Model: GP605 **Ref. No.:** FF-T01-K1-000007-02

Subject UPDATING THE IMAGE ADJUSTMENT BASIC PROCEDURE

: The steps used in the procedure have been updated to prevent darkening of image, possibly occurring Reason

2 Checking the Printer Side (1/2)

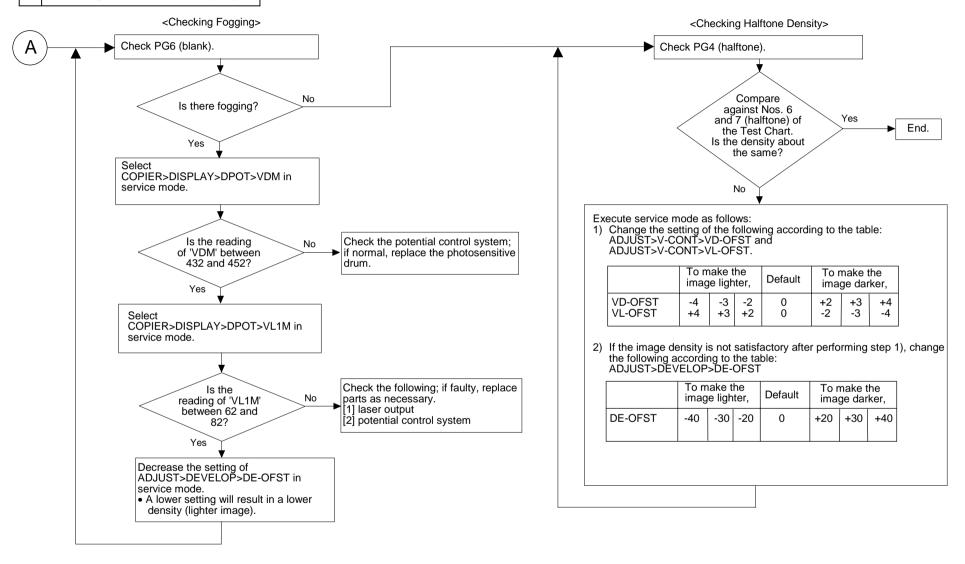
when performing the "Image Adjustment Basic Procedure" found in the Service Manual (pp.13-3

Checking the Printer Side (1/2) <Checking the Image> • Use PG4, PG7, and PG8. <Checking the Density Slope> <Checking the Solid Black Density> Are there No vertical lines in Check the image using PG4. Check PG8 (solid black). the image? Yes Is there a Is the image Yes difference in No free of blurring and the Clean the following, and check them density between density optimum? for adhesion of foreign matter: front and [1] dust-proofing glass rear? [2] each charging assembly No Yes Select COPIER>DISPLAY>DPOT>VDM in service mode. No Is the rear side lighter? Are there No vertical lines in Check the primary charging system Is the reading of Yes the image? and the potential control system; if 'VDM' between normal, replace the photosensitive 432 and 452? Turn the adjusting screw at the Turn the adjusting screw at drum. Yes the front of the primary rear of the primary charging charging assembly assembly counterclockwise Yes counterclockwise (maximum (maximum of 2 turns). Select COPIER>DISPLAY>DPOT>VL1M in service mode. of 2 turns). Executina Potential Control Check the following; if faulty, replace Is the reading parts as needed: Turn off and then on the power switch, and of 'VL1M' between [1] laser output generate one test print using PG7 or PG4. 62 and 82? [2] potential control system Caution: Yes [1] If a difference in density remains after giving the adjusting screw 2 turns on one side (a single turn causes a change of about 0.7 mm), check the charging assembly, scanning lamp, and scanner for dirt. Yes Check the following of the Is the test print PG6 When turning the adjusting screw counterclockwise, be sure the developing assembly system: distance between the wire and the grid wire will not be less than (blank) foggy? [1] developing bias 7.5 mm. [2] coating of toner on the sleeve No Reference: Set the following to '2' through '7' in service mode: If the wire is moved away from the photosensitive drum, the image OPTION>BODY>CNT-W/HM density will increase; if it is moved to the drum, the density will • A higher setting will make the density higher (darker). decrease.
